No. 51/09 Marine Version 3

Transmittal

Title: Introduction of Leafield GIST hose assembly, c/w bayonet termination at both ends. Applies only to new build and Non-Operationally Packed new build liferafts.

FIGURE 01
Cylinder and hose positioned correctly in relation to liferaft floor

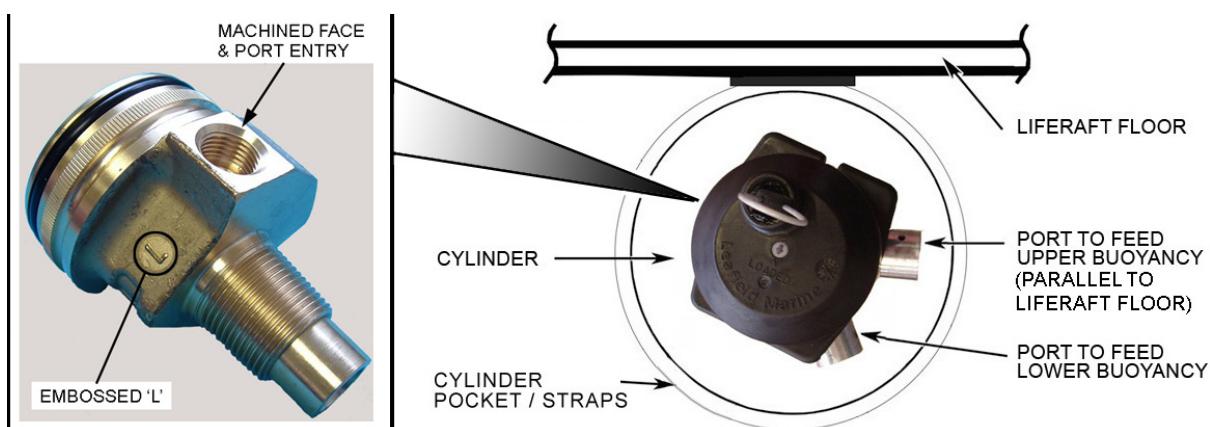
Documented procedures for the operational packing of MkIII and MkIV liferafts specify the position of the cylinder valve/hoses relative to the liferaft floor, (FIGURE 01), and container, (FIGURE 02). These procedures ensure the serviceability of the inflation equipment during operational packing and use.

5.1.9 Continue with the documented assembly procedures. At all times, ensure the cylinder is orientated so that the upper buoyancy hose runs parallel to the liferaft floor, (FIGURE 01). The lower buoyancy hose will be automatically in the correct position, (FIGURE 06).

FIGURE 02
Correct orientation of cylinder head in relation to container

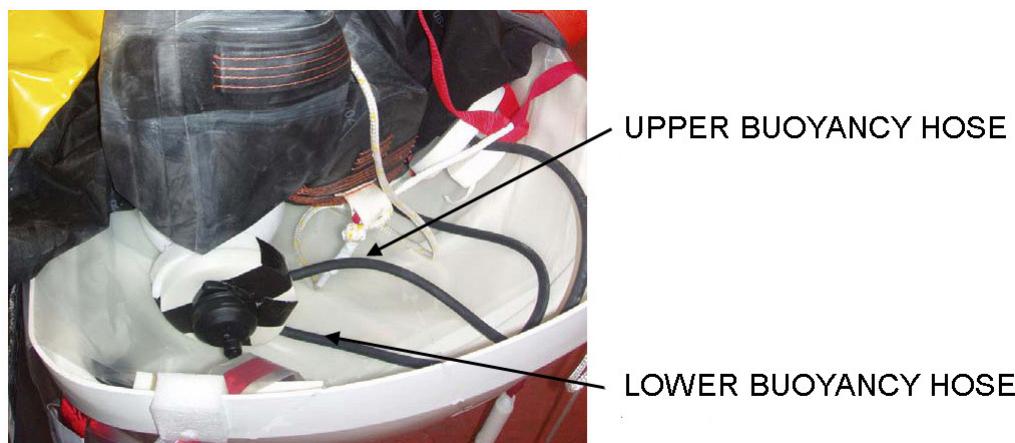
It is possible to position the cylinder within the container so that the hose to the upper buoyancy is unsuitably aligned, relative to the raft hull and container, (FIGURE 03). An incorrectly arranged upper buoyancy hose would also place the lower buoyancy hose in a potentially unsafe position, which could result in the lower buoyancy hose becoming damaged.

FIGURE 05
Cylinder and hose assembly
(exploded view shown for clarity)

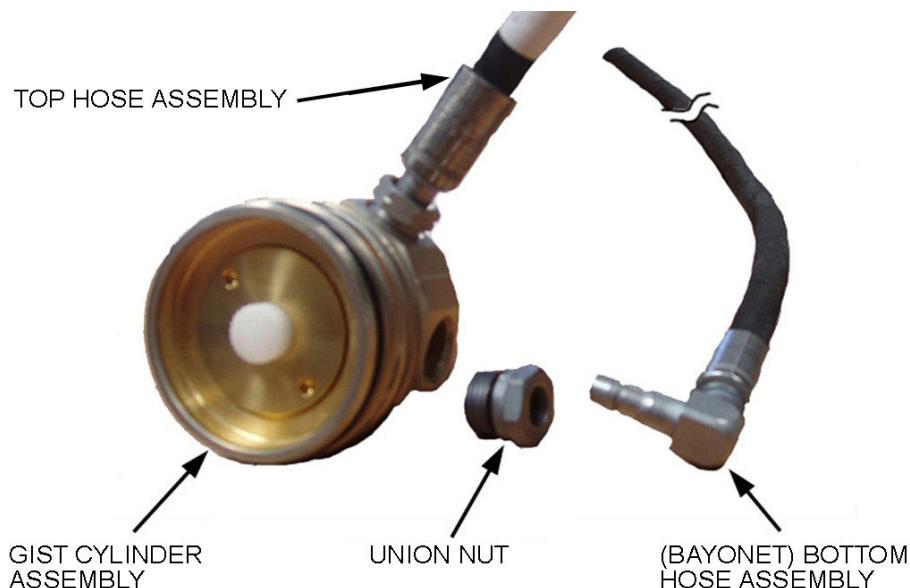
4. Parts required (FIGURE 05)

5.1.6 Insert the union nut/hose assembly into the appropriate threaded outlet port of the cylinder valve, (FIGURE 05).

5.1.8 The new hose assembly c/w double bayonet fittings is shown in, (FIGURE 05). It is connected to the cylinder valve via a new Union nut c/w O-ring.

5.1.7 Tighten the Union nut to the cylinder valve using the correct torque value of 19 Nm ±1 Nm.
